### METHOD AND DEVICE TO IMPROVE THE RATIO OF OXYGEN MASS VERSUS FUEL MASS AT IGNITION IN COMBUSTION MECHANISMS OPERATING WITH FLUID HYDROCARBON FUEL

# ETV CONFIDENTIAL REPORT ON FUEL PREHEATING INVENTION

**Re. Your letter dated April 18, 1999 regarding CGRI's Evaluation of the  
Tylon Fuel Saver Technology.**

## Tylon Fuel Saver (Furnace Cycle 2)

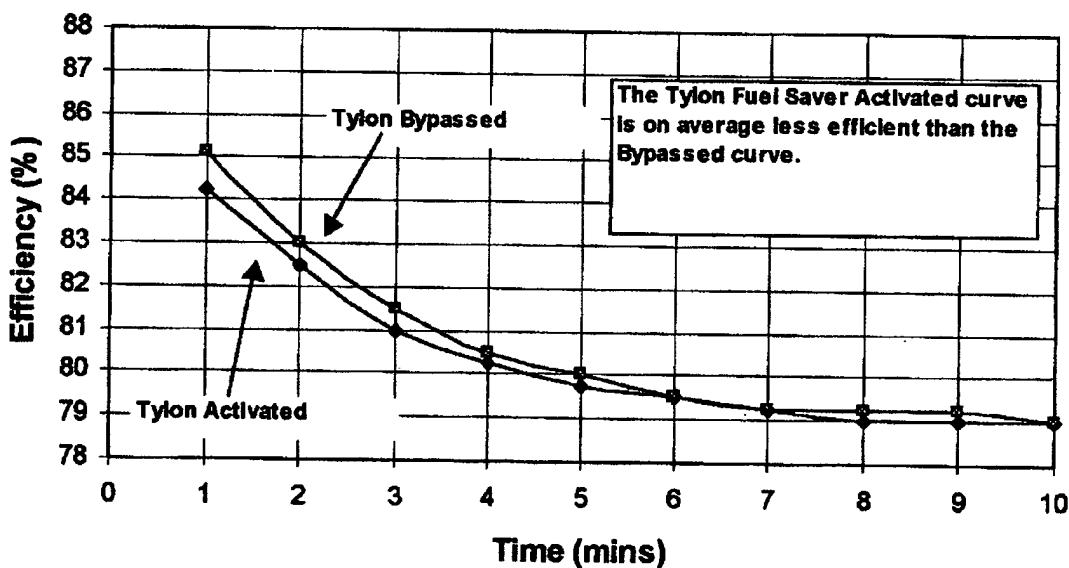
These overall efficiency figures were calculated using the "flue loss method". This method determines the sensible and latent energy lost in the combustion products going up the flue. The figures are determined by temperature differences between what goes in and what comes out and also from the flue Carbon Dioxide concentration, which gives an indication of the excess air level in the flue.

**The Efficiency determined using this method includes both the energy output in the load air and the energy lost from the furnace to its surroundings.**

The energy lost from the furnace to its surroundings (casing or jacket losses) was not measured, however they are generally not very high and for a furnace would contribute to the heating of a house. It is CGRI's opinion that the casing losses would not have changed significantly when the Tylon Fuel Saver was activated as compared to its being bypassed, during the ITS testing.

There was a net decrease in the energy supplied to the furnace and an increase (or no change) in the energy being lost up the flue, so unless there was a significant change in the casing losses (which cannot be determined) there is no explanation for the dramatic increase in energy output in the load air being claimed.

CGRI is unwilling to support any claim that implies that the first law of thermodynamics is being broken.
